IOWADOT Highway Division

STANDARD DESIGN - 40' ROADWAY, 3 SPAN BRIDGES

TEE PIER CAP & COLUMN DETAILS

RS40-116-10

FRONT ELEVATION

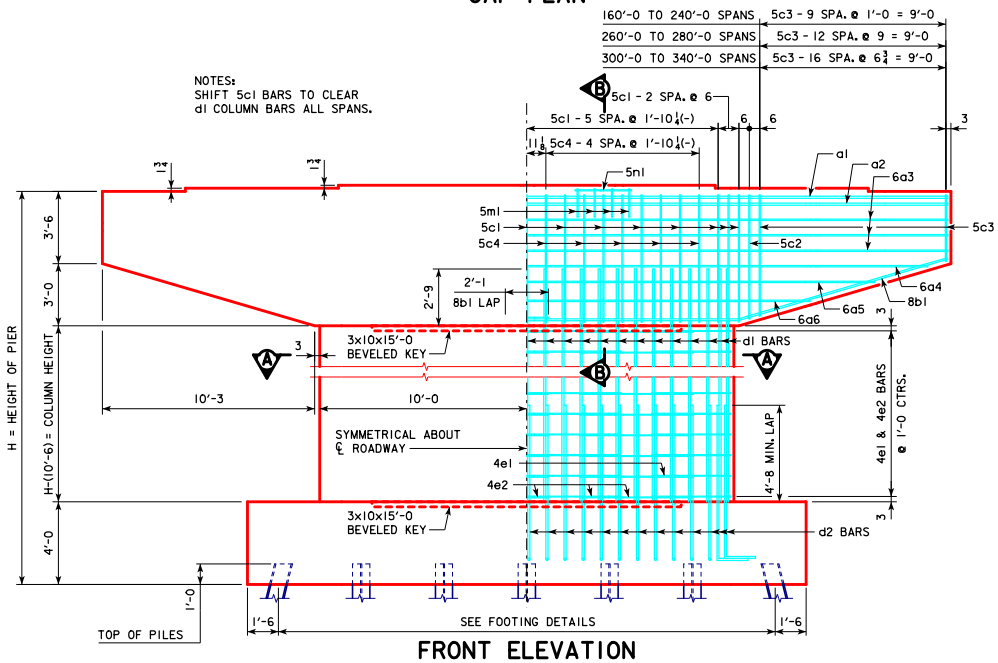
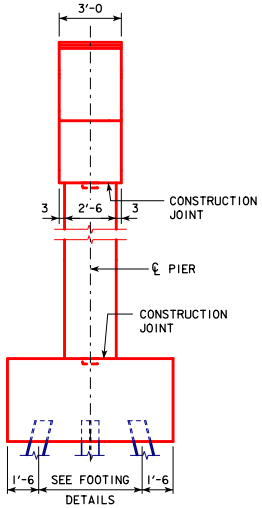
REVISED 10-2016 - CHANGED BEVELED KEYWAY ON PIER COLUMN CAP AND FOOTING TO 3"x10"x15'-0 (WAS 2"x8"x17'-0). KEYWAY LENGTH CHANGED TO BE 5'-0 LESS THAN WIDTH OF PIER COLUMN.
